Service Bulletin

SUBJECT: Service Update for Inventory Vehicles Only
Incorrect Material Used for Transmission O-Ring
Expires September 30, 2013

MODELS: 2012-2013 Buick Regal
2013 Buick LaCrosse
2013 Chevrolet Malibu
Equipped with 6-Speed Hybrid Automatic Transmission (MHH)

Date: December 3, 2012
Subject: 12222B - Service Update - Inventory Vehicles Only
Incorrect Material Used for Transmission O-Ring
Revised Part Information Section
Models: 2012-2013 Buick Regal; 2013 Buick LaCrosse and Chevrolet Malibu
Equipped with 6-Speed Hybrid Automatic Transmission (MHH)
To: All Buick and Chevrolet Dealers
Attention: General Manager, Service Advisor, Service Manager, Parts and
Service Director, Parts Manager, New Vehicle Sales Manager,
and Warranty Administrator

2913458

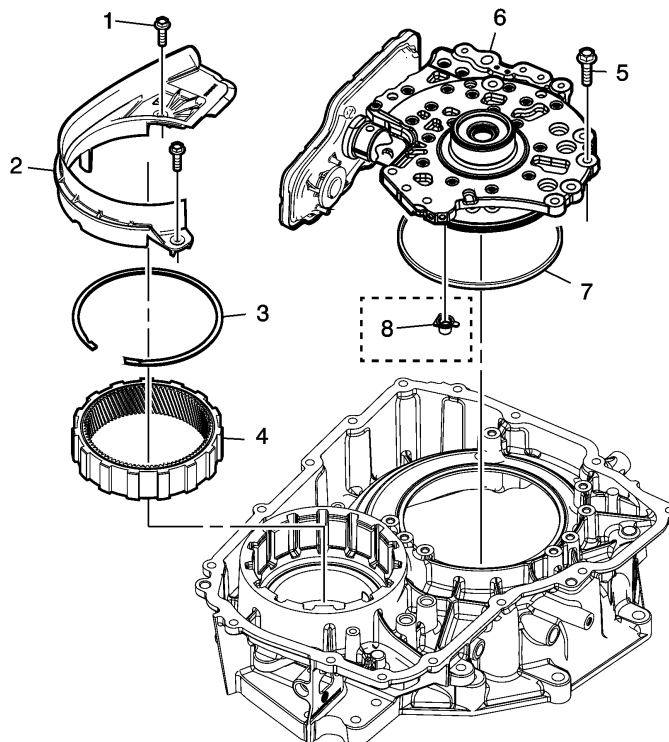
Note: The fluid inlet pump seal (1) may be torn as shown in the photo below.

1. Install a new A/Trans Auxiliary Fluid Inlet Pump Seal (8).
